Appl'n No: 09/807,634
Amdt dated March 19, 2004
Reply to Office action dated November 19, 2003

AMENDMENTS TO THE DRAWINGS:

Fig. 11

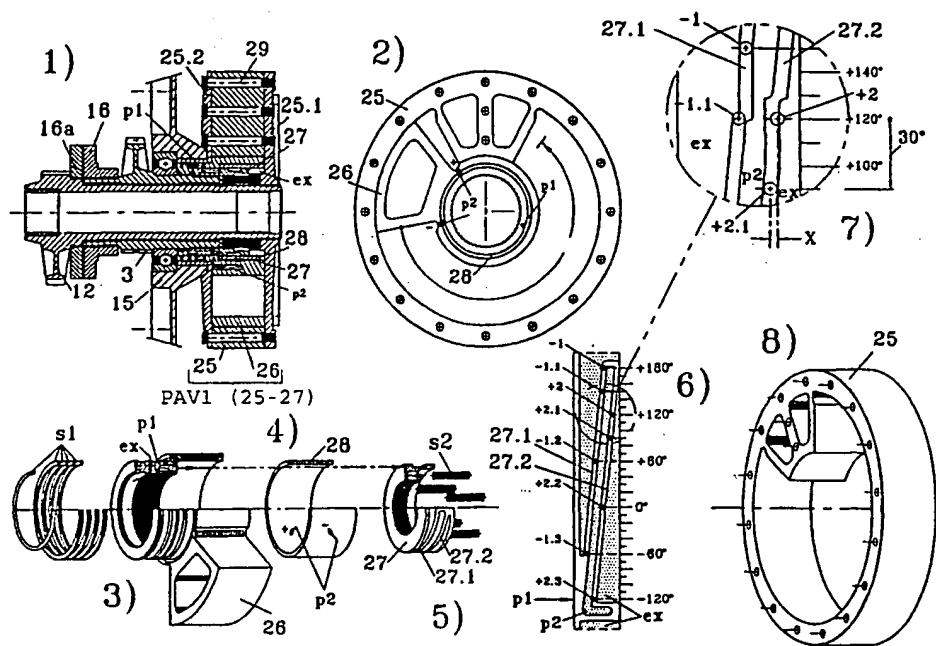
The attached sheets of drawings include changes to Figures 11, 11a, 11b, 12, 13b, 14 and replaces the original sheet of the same Figures. In each of the noted Figures, the phase angle variator as set forth in the claims has been shown in the drawings.
